NAME OF PROJECT: Oak Run Commercial Unit 9; Located on Loop 337 approximately 700 feet north of State Hwy 46; New Braunfels, Texas

Re: Edwards Aquifer, Comal County
NAME OF PROJECT: Oak Run Commercial Unit 9; Located on Loop 337 approximately 700 feet north of State Hwy 46; New Braunfels, Texas
TYPE: Technical Assistance Regarding a Modification of Water Pollution Abatement Plan (WPAP), 30 Texas Administrative Code (TAC) §213.5(b)
Edwards Aquifer Protection Program File No. 1605.02

Re: Oak Run Commercial Unit-9 Water Pollution Abatement Plan
TNRCC Project No. 1605.00
Technical Letter – Relocation of Basin A

SUBJECT: RELOCATION OF BASIN "A"
PROJECT: OAK RUN COMMERCIAL UNIT-9
DRAWN BY: DJM JOB NO. 5123.04
CHECKED BY: _____ DATE: 5/14/01

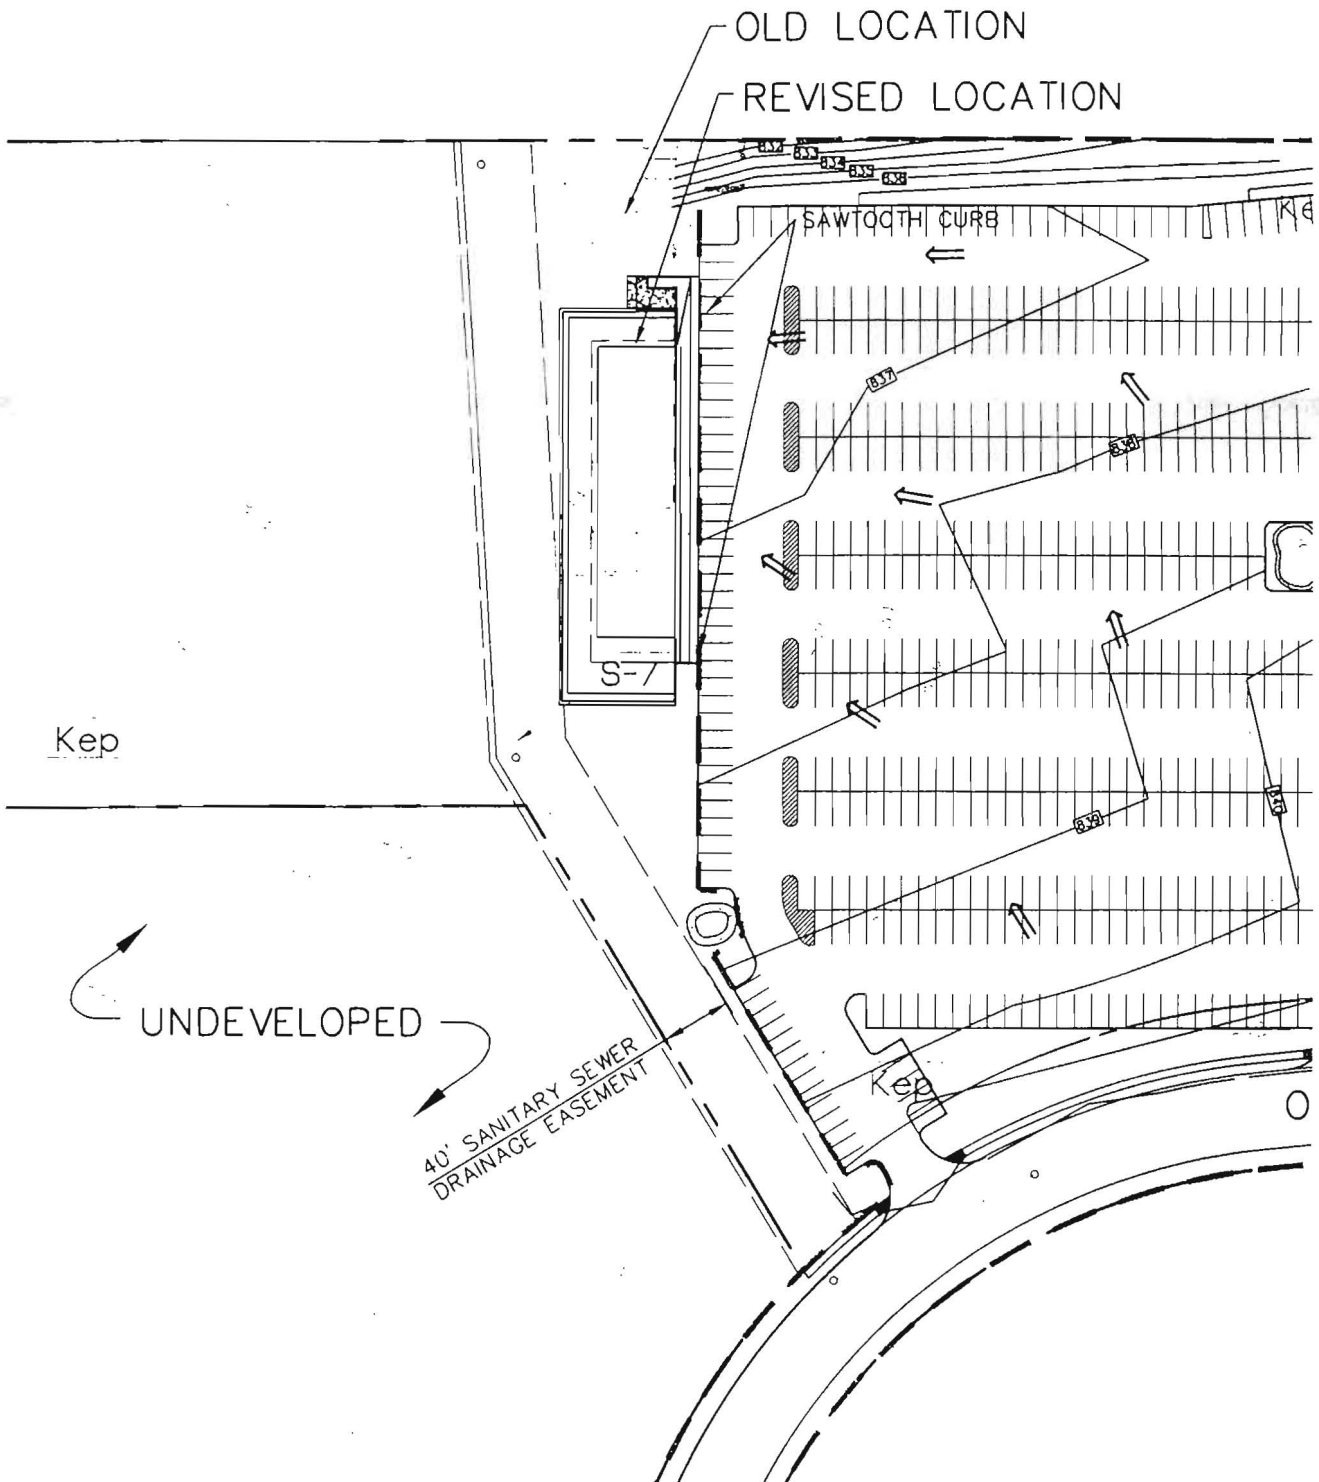
In order to accommodate the grading revision, it is also necessary to adjust Basin A. Basin A is proposed to be moved 67' to the southwest. No changes in elevation are proposed for the basin inlet, water surface elevation, overflow weir elevation or invert of the basin. No revisions to the capacity of the basin are proposed and the basin watershed will remain unchanged.

SUBJECT: RELOCATION OF BASIN "A"
PROJECT: OAK RUN COMMERCIAL UNIT-9
DRAWN BY: DJM JOB NO. 5123.04
CHECKED BY: _____ DATE: 5/14/01

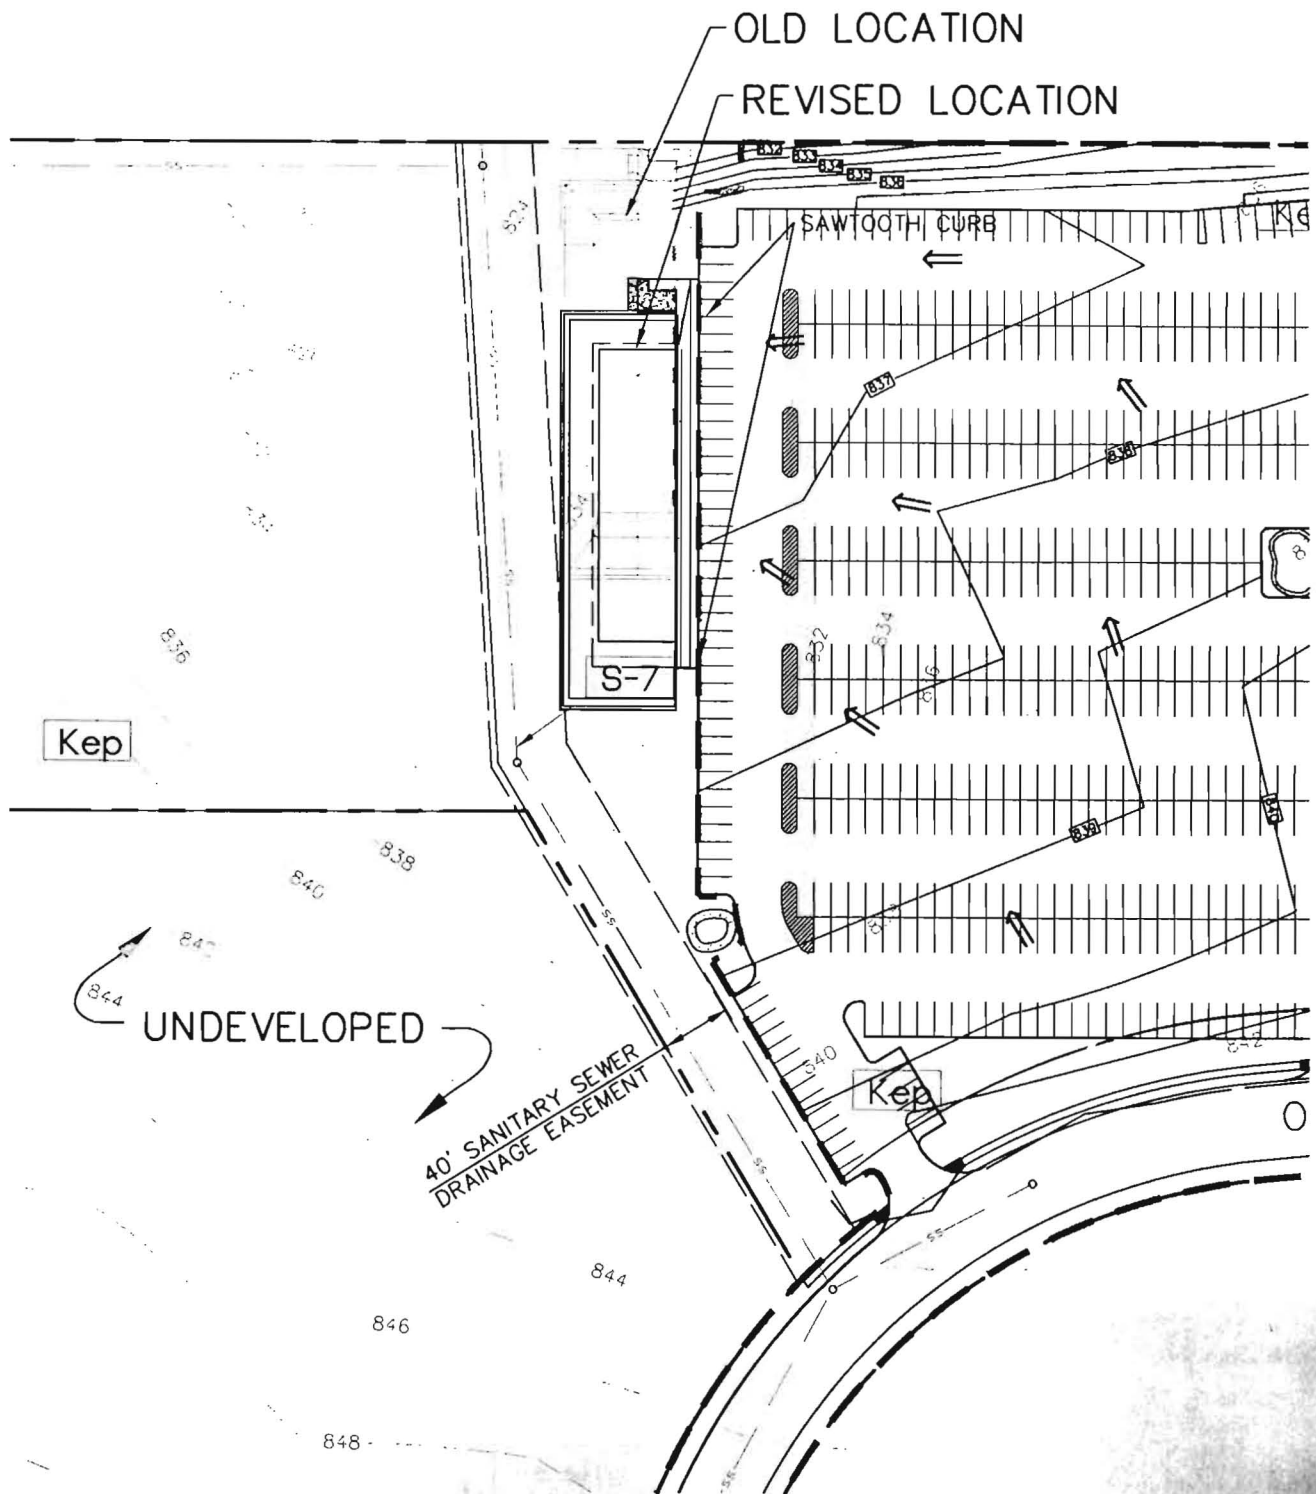
In order to accommodate the grading revision, it is also necessary to adjust Basin A. Basin A is proposed to be moved 67' to the southwest. No changes in elevation are proposed for the basin inlet, water surface elevation, overflow weir elevation or invert of the basin. No revisions to the capacity of the basin are proposed and the basin watershed will remain unchanged.

OAK RUN COMMERCIAL UNIT-9
TEMPORARY POLLUTION ABATEMENT PLAN

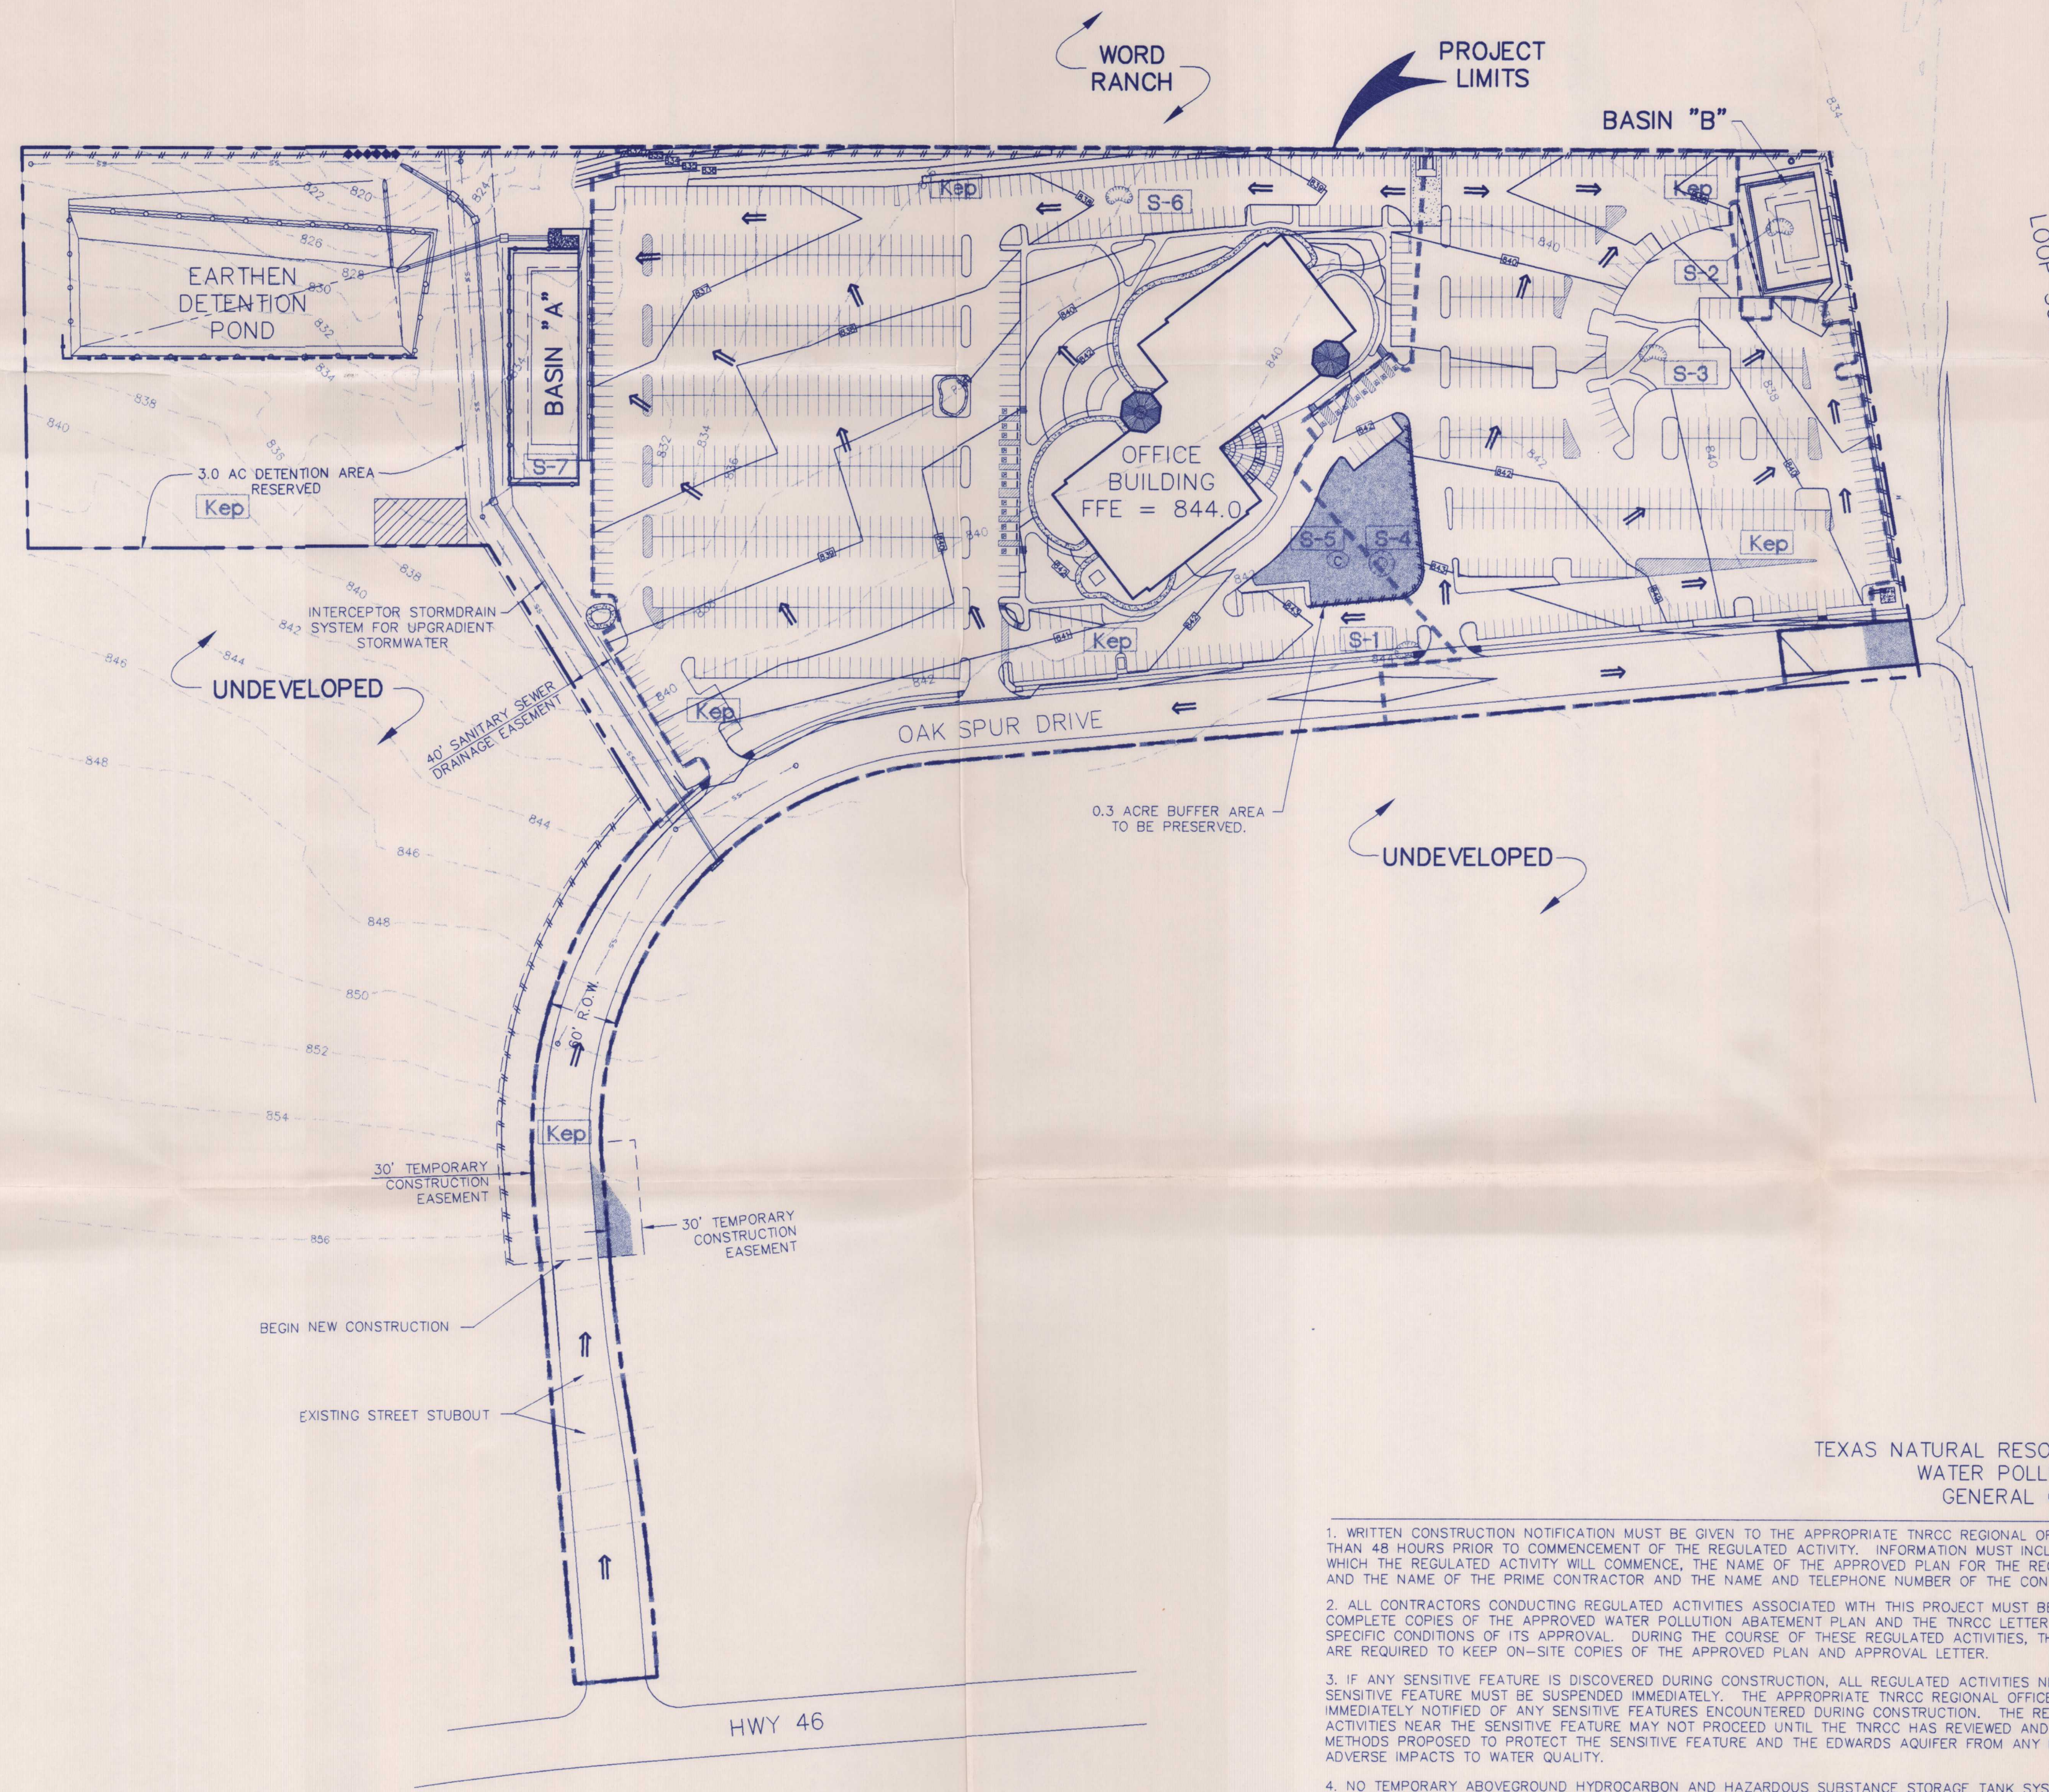
REVISIONS:
5/7/01: BASIN "A" LOCATION MOVED
